PROJECT NAME: BATTERSHALL ADDITION

PROJECT NUMBER: 2024040001

APPLICATION: DRC WAIVER REQUEST #31355

DEVELOPMENT REVIEW COMMITTEE WAIVER REQUEST FORM

SITE PLAN

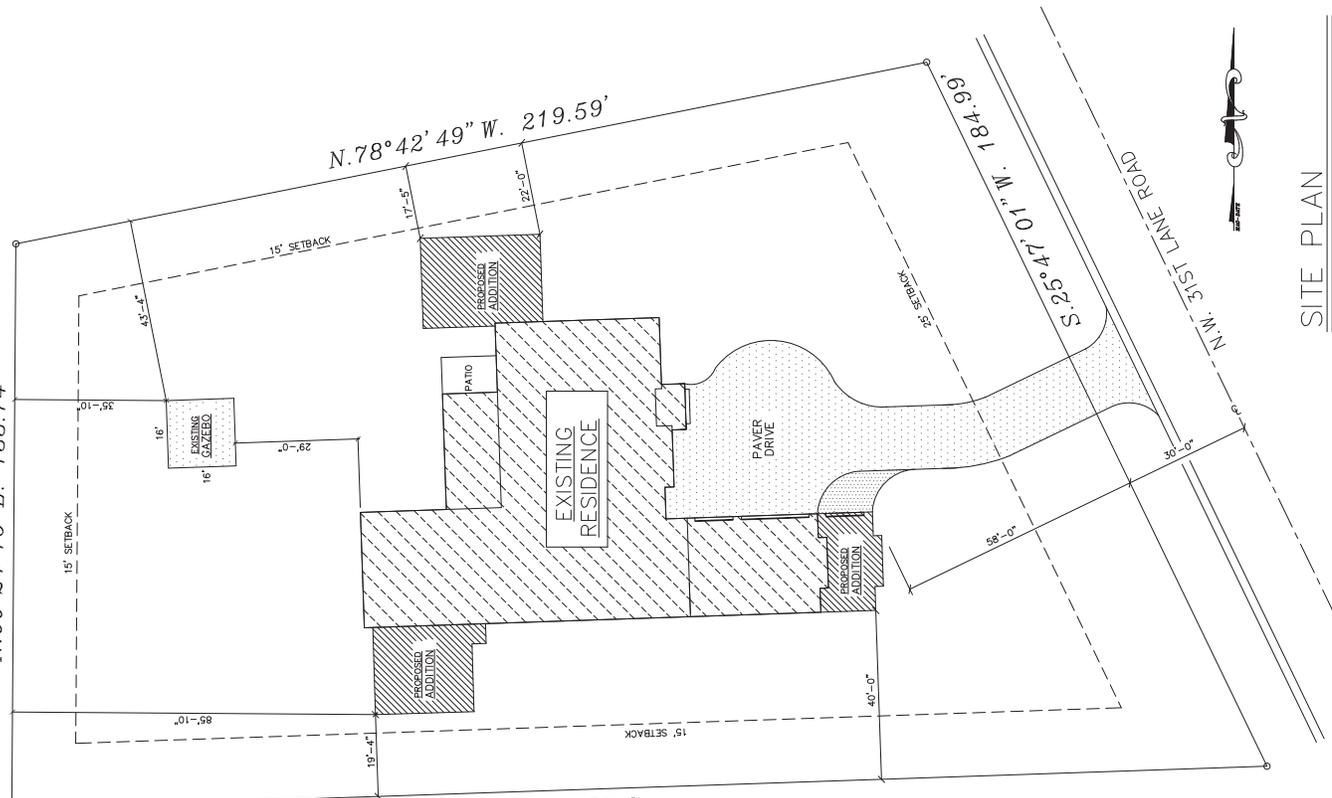
- 4 DEPARTMENT: ENGDRN - STORMWATER REVIEW
REVIEW ITEM: LDC 2.21.1.A(1) - Major Site Plan
STATUS OF REVIEW: INFO
REMARKS: CONDITIONAL APPROVAL subject to working with Stormwater staff under the following conditions: 1) The applicant must provide stormwater control of the additional runoff from the impervious coverage at the 100-year, 24-hour storm from the proposed project. 2) A permit/inspection hold will be in effect until a sketch of the proposed stormwater controls is provided to Stormwater and approved. 3) A Final Hold will be in effect until: a) Stormwater staff conducts a final inspection. Please note that stormwater controls and all disturbed areas must have vegetative cover established at time of final inspection. b) The applicant must provide a final sketch, noting the horizontal extents and volume capacity of the stormwater controls.
The applicant owns a 0.91-acre parcel (PID 12670-040-00) and according to the MCPA, there is approximately 12,336 sf existing impervious area on-site. The applicant is proposing to add 1,329 sf for a home addition. The total existing and proposed impervious area is 13,665 sf. The site will be approximately 3,665 sf over the allowed 10,000 sf per the Golden Ocala Unit 1 & New Revised Subdivision. There are no FEMA Special Flood Hazard Areas or Flood Prone Areas on the property. The HOA/POA is still active, and must provide a letter of no-objection to the project. Staff recommends approval with conditions.

Section & Title of Code: 2.21.1.A - MAJOR SITE PLAN
Reason/Justification for Waiver Request: Requesting waiver to a Major Site Plan for 1329 sf addition to existing SFR. The site impervious coverage will become 13665sf; allowable is 10,000 sf
Requesting to work with Stormwater to address the runoff storage of excess.
